Duane Arnold Plant

April 23, 1976
IE-76-652

PROPOSED CHANGE ETS-18 TO DAEC TECHNICAL SPECIFICATIONS

FIGURE 4.3-1 RADIOLOGICAL ENVIRONMENTAL MONITORING PROGRAM SAMPLING STATION

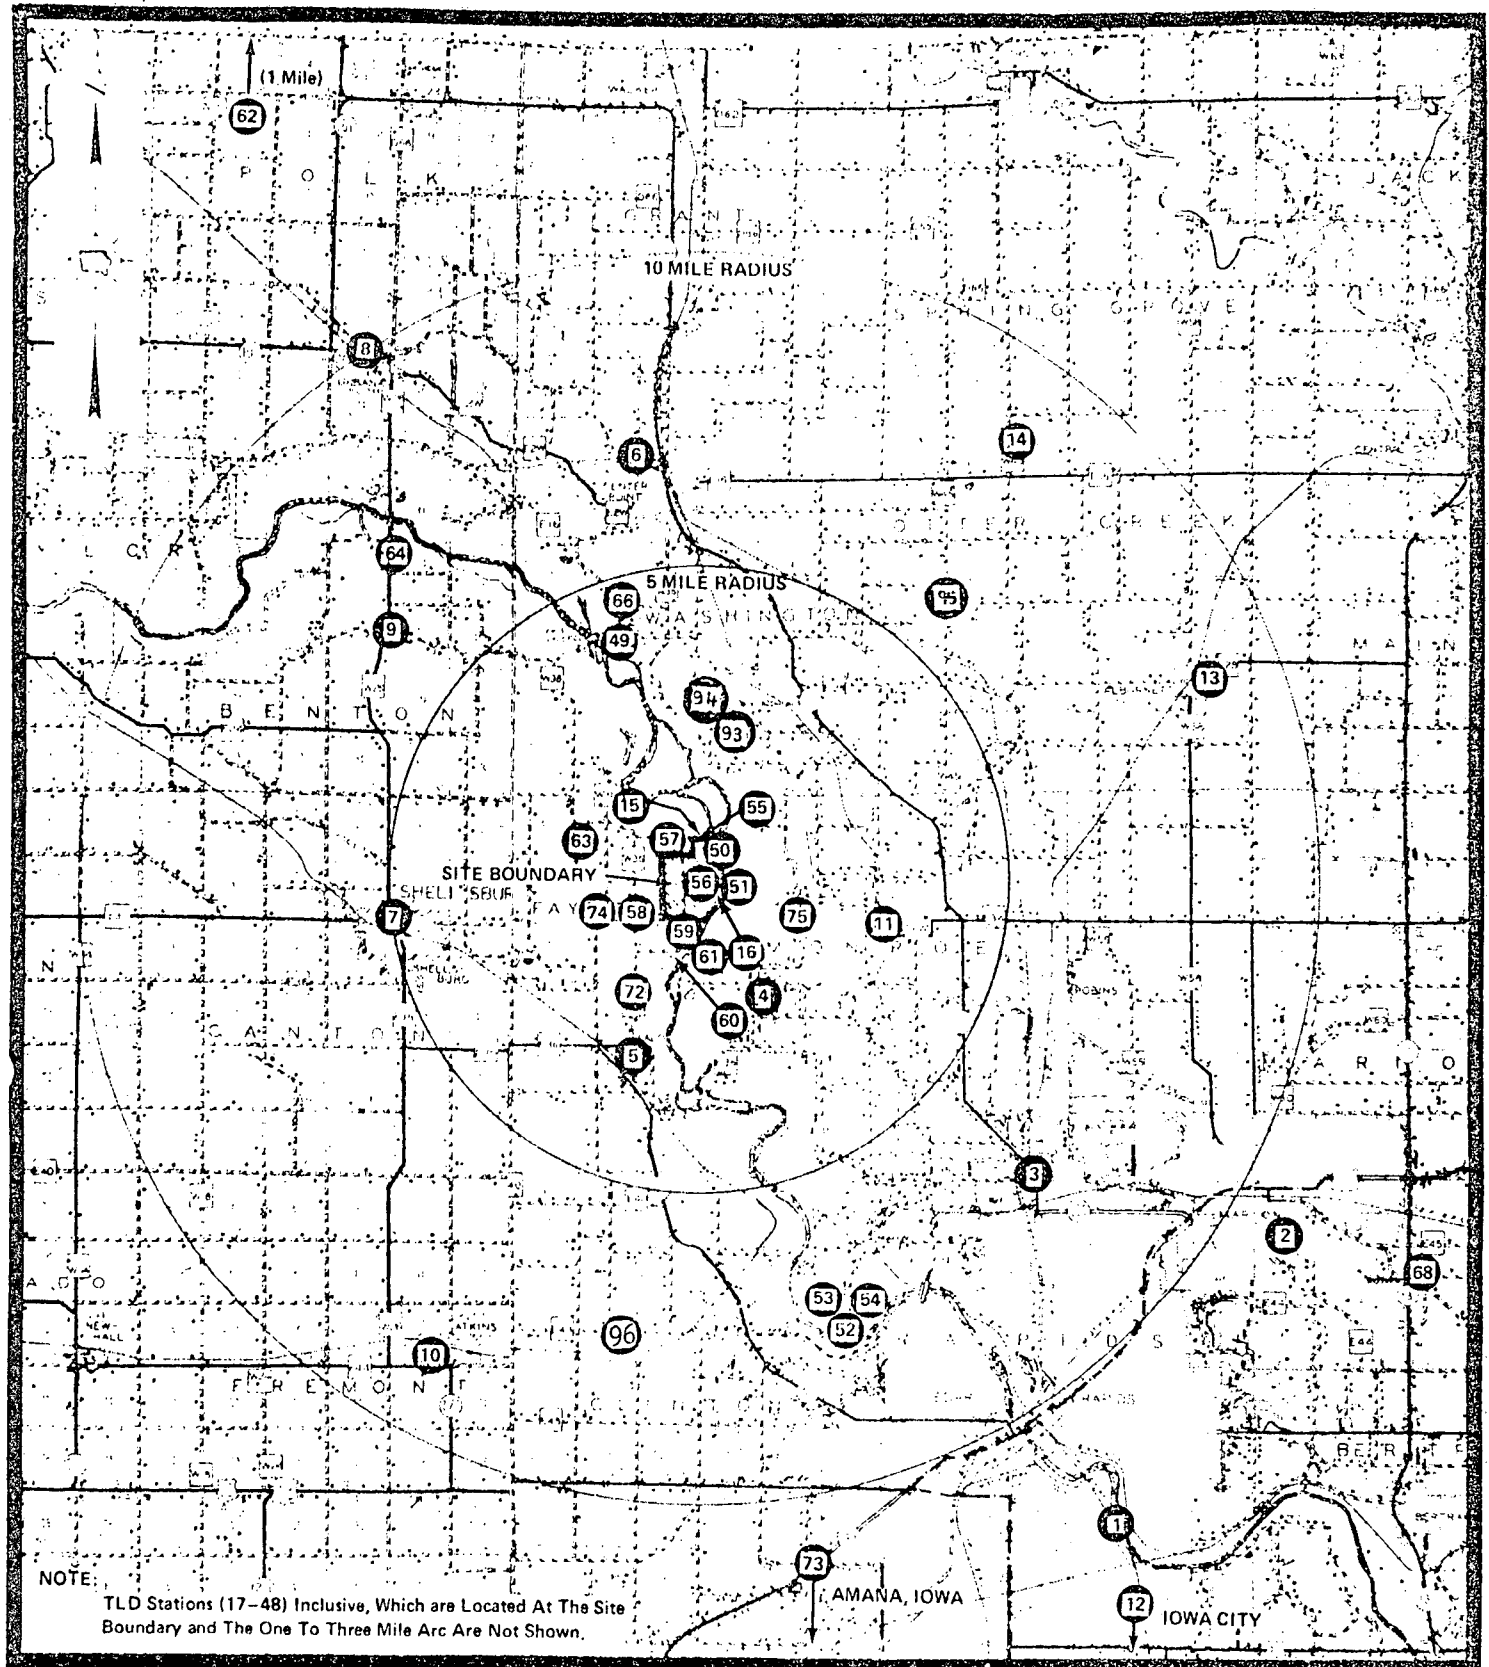
On Figure 4.3-1, "Radiological Environmental Monitoring Program Sampling Stations" delete sample point "71" and add sample point "96".

The farm identified as sample point 71 no longer has milk available for use in the Environmental Radioactivity Monitoring Program. The new sample point being added is an adjacent farm so sample will still be available from the same area. Since the soil and vegetation monitoring programs use the same sample points as the milk monitoring program, the same sample point change has been made there also. For these reasons, the above change is proposed.

FIGURE 6.2-1

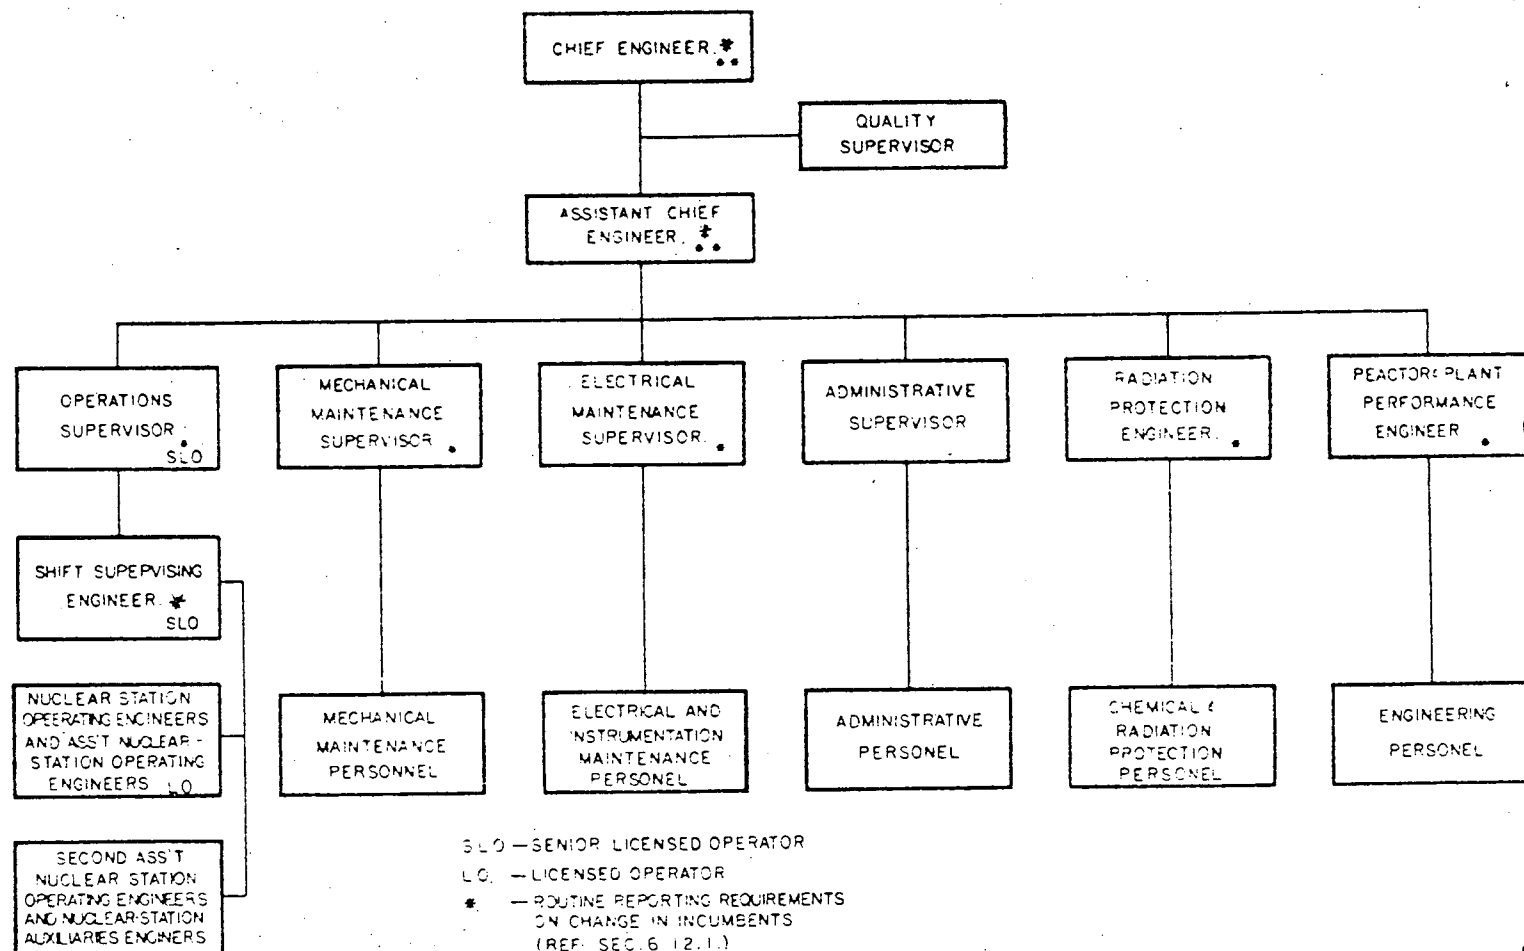
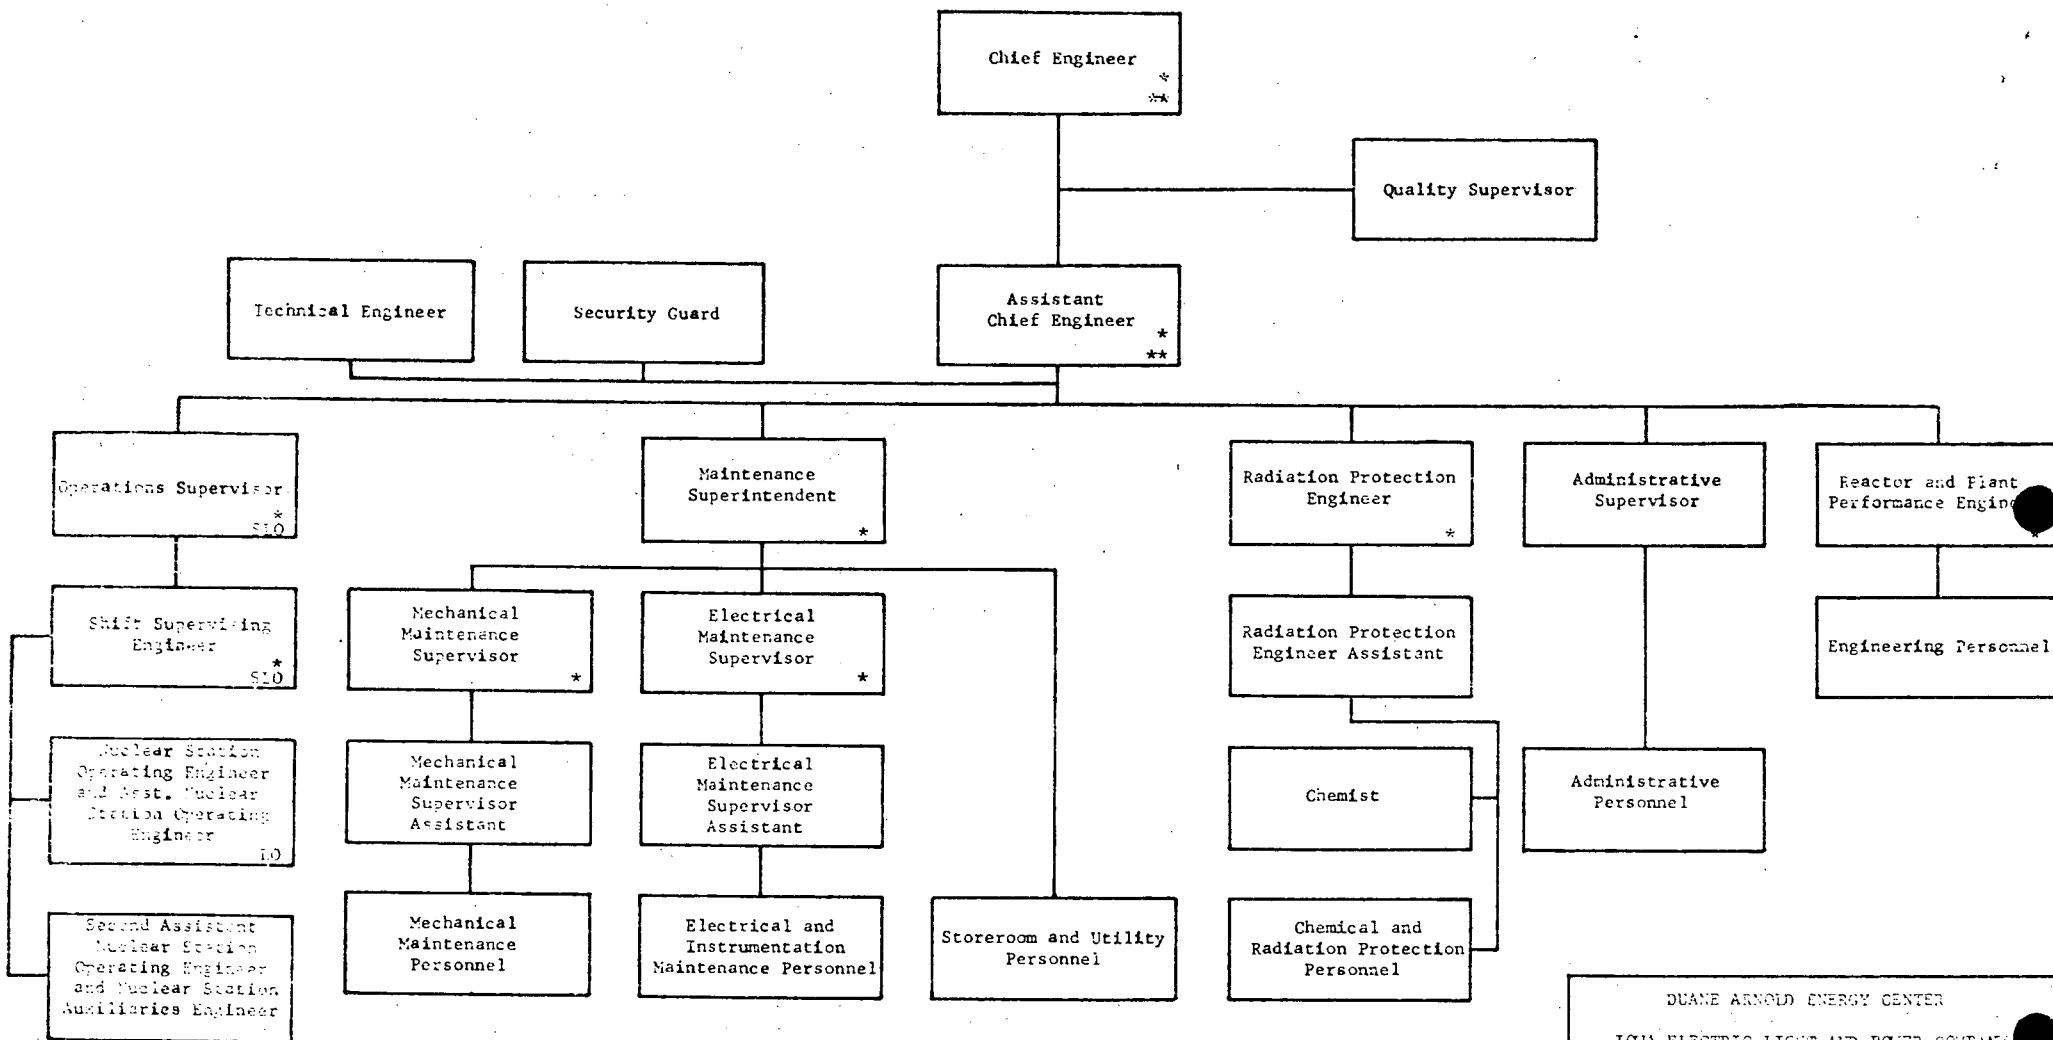
Added the positions of Technical Engineer and Security Guard as reporting to the Assistant Chief Engineer.

Added the position of Maintenance Superintendent and showed the Mechanical Maintenance Supervisor, Electrical Maintenance Supervisor and Storeroom and Utility Personnel as reporting to the Maintenance Superintendent.

Added the positions of Mechanical Maintenance Supervisor Assistant, Electrical Maintenance Supervisor Assistant and Radiation Protection Engineer Assistant.

Changed reference on chart regarding routine reporting requirements on change in incumbents from "Ref. Sec. 6.12.1" to "Ref. Spec. 6.11.1".

These proposed changes are being submitted to reflect organizational changes made at the Duane Arnold Energy Center. These organizational changes have demonstrated themselves to result in a smoothly operating and efficient plant staff.
